Agenda
Hearing Examiner Meeting
Monday, August 9, 2021
Join the Zoom meeting [here](#)
Public Telephone Access: (206) 337-9723 or (253) 215-8782
Meeting ID No. 872 2126 7401

S2021-103 Fairhaven Townhome Estates

**CITY OF RICHLAND DEVELOPMENT SERVICES DIVISION
STAFF REPORT TO THE HEARING EXAMINER**

PROPOSAL NAME: Fairhaven - Preliminary Plat

Figure 1 - City of Kennewick - Standard Drawing 2-10 sheet 1 of 9 (partial)

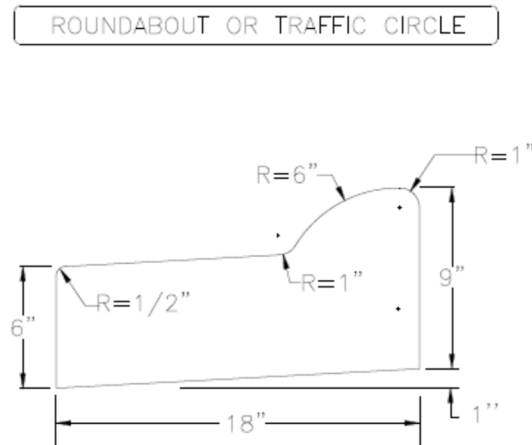
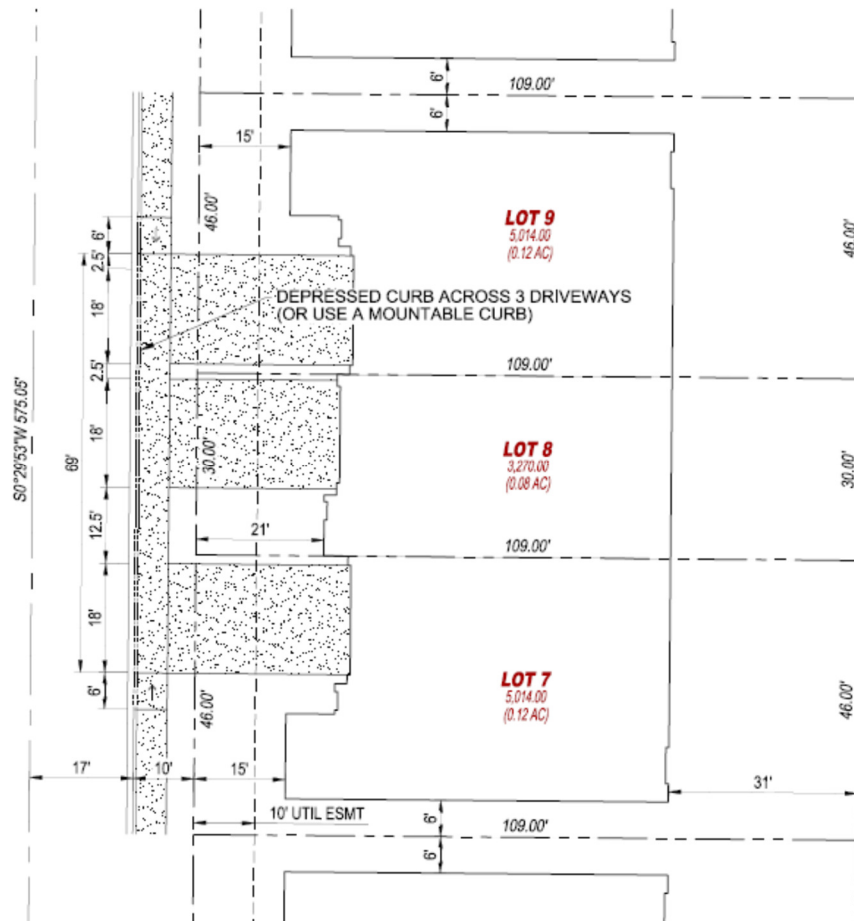
We request that the city allow either: 1) mountable curbs so that driveways don't need to be dropped (similar to the City of Kennewick curb at roundabout, see Figure 1), or 2) continuous depressed curbs for driveways where there is insufficient frontage to have an 18-ft wide driveway with transitions on each side and 5 ft between adjacent transitions (see figure 2 for an example).

PRELIMINARY PLAT - OVERALL PLAN FOR:

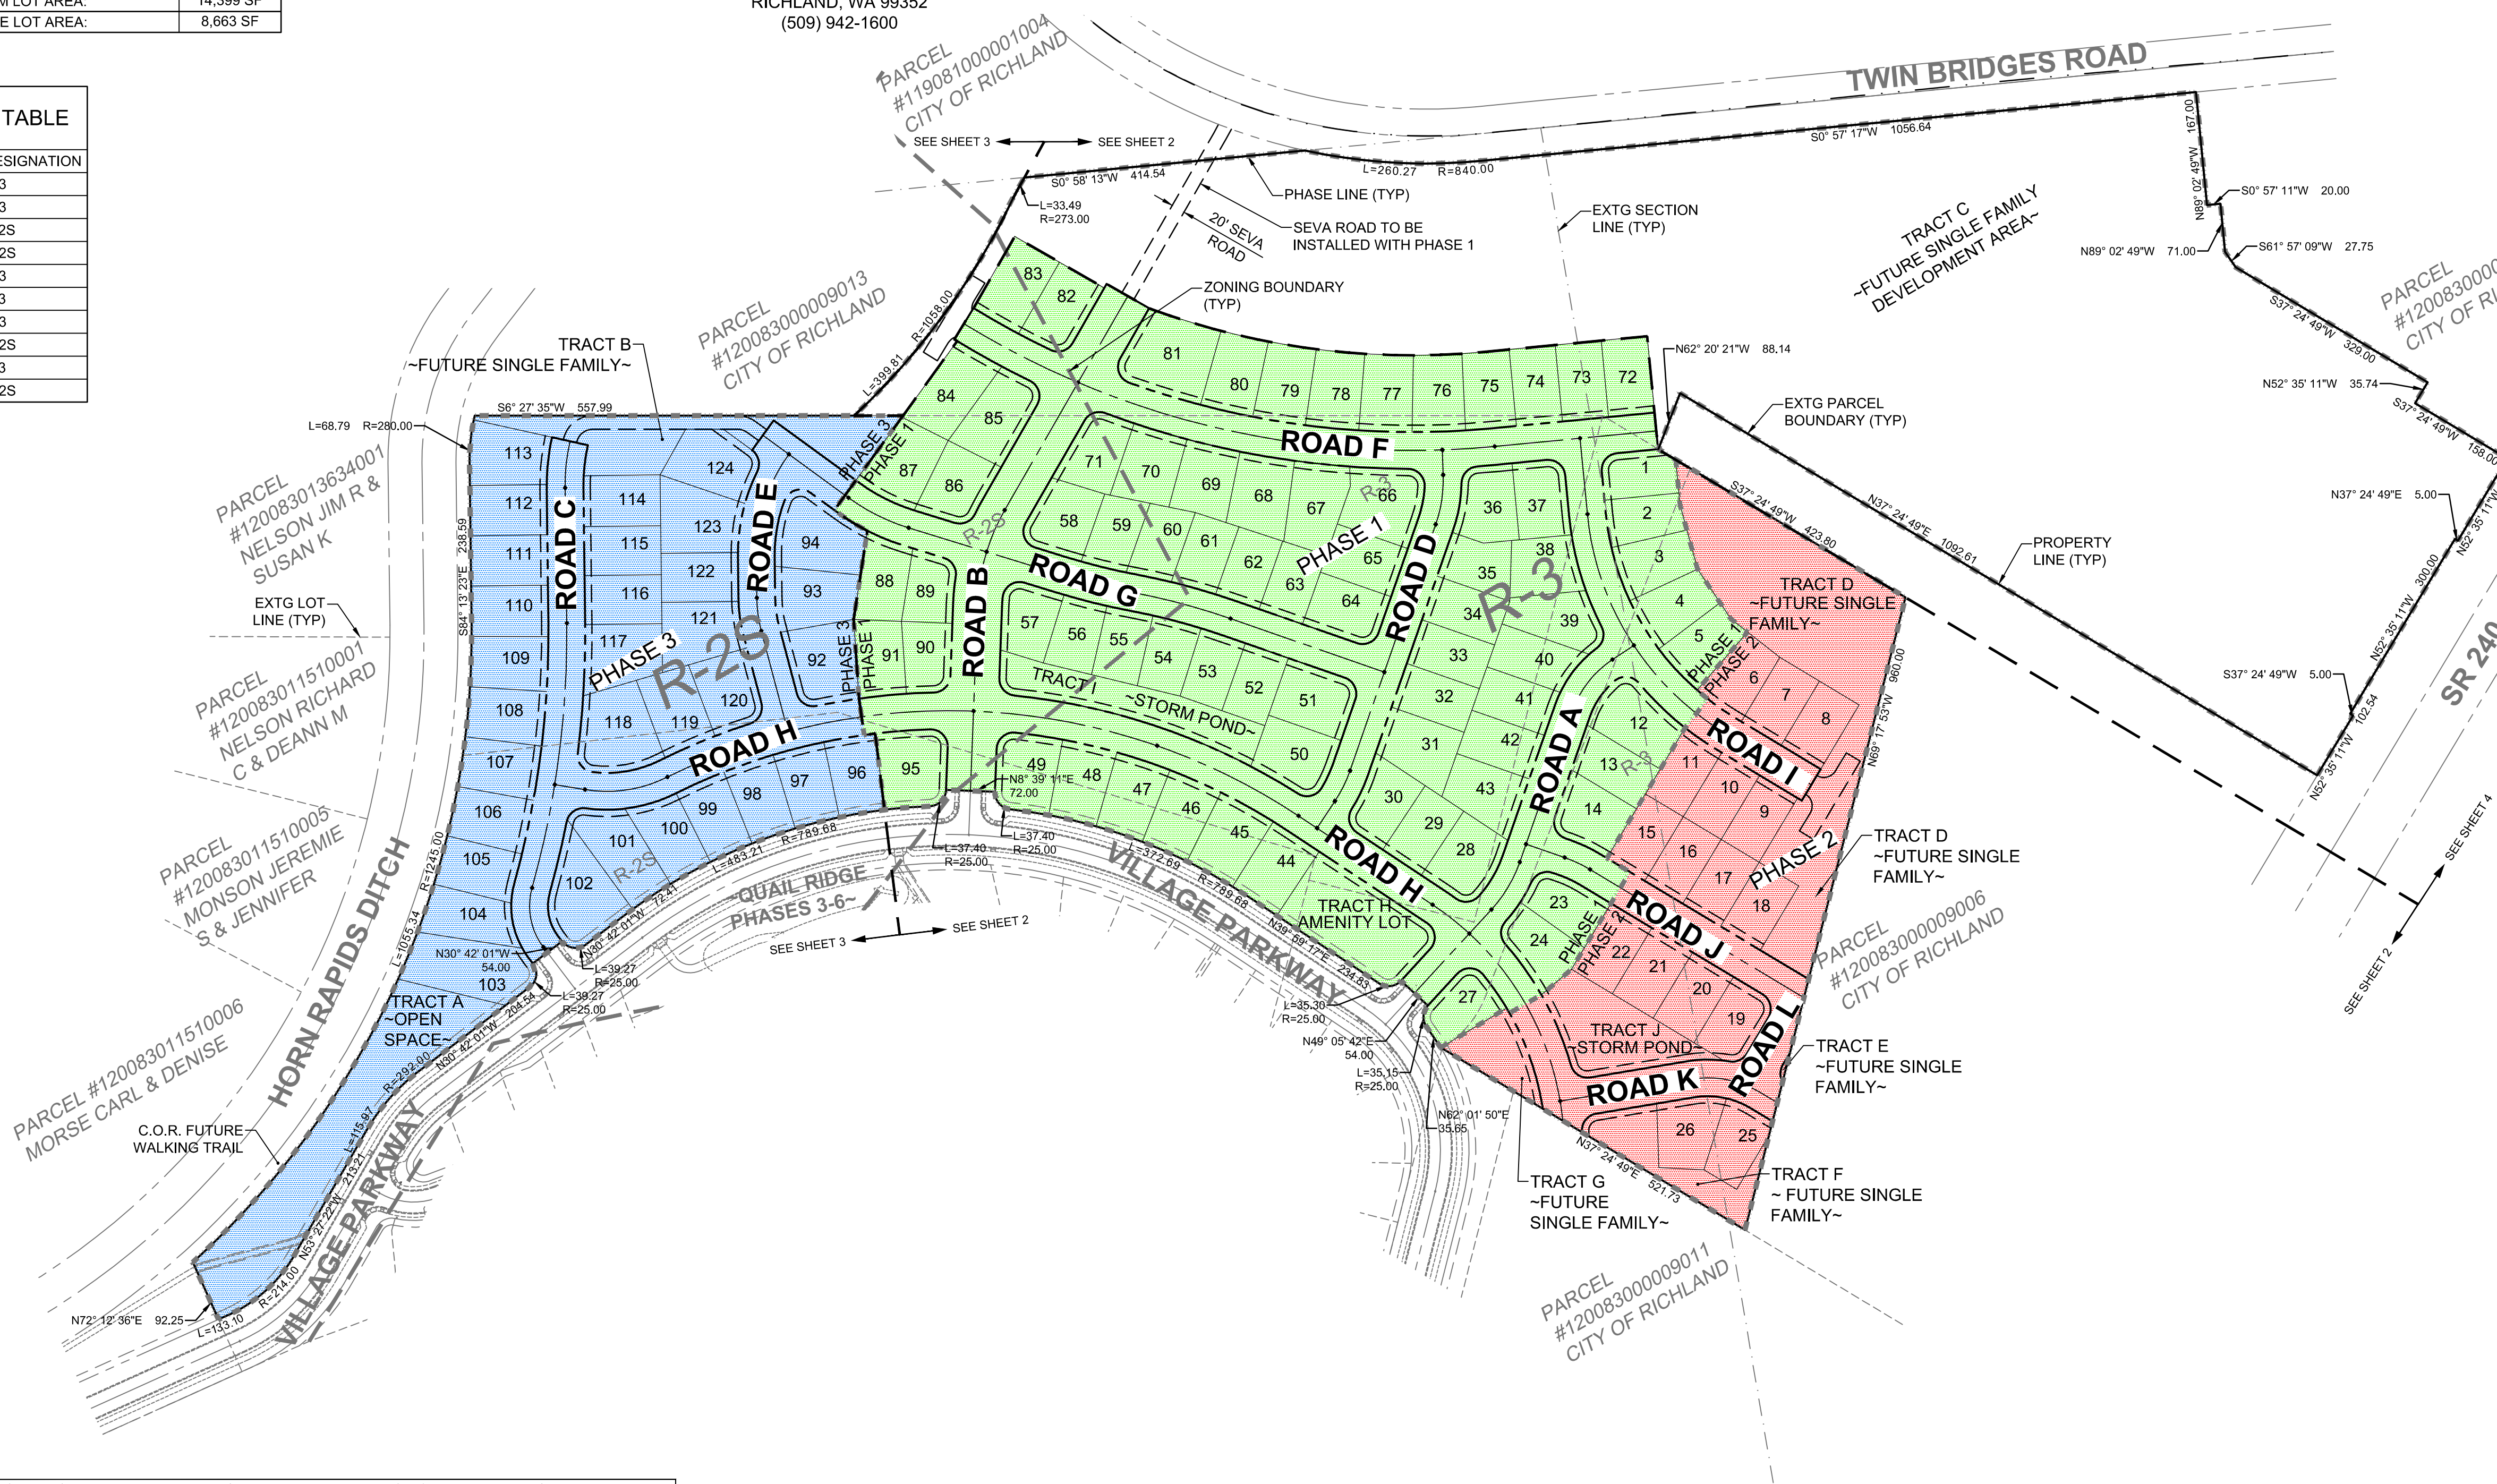
1. Road F is mislabeled on Sheet 3 of the pre-plat.
2. Some of the road corridors on sheets 2 & 3 are missing widths.

17. The "phase line" across the north side of Sheet 2 of the preliminary plat appears to cut through Lot 25 and also the intersection of "Road L" and "Road J". This road intersection shall be constructed in its entirety to the northern curb returns of Road J. This may require an adjustment of the north pre-plat boundary to encompass this additional ground, or an easement for this road construction that is outside of the pre-plat boundary.
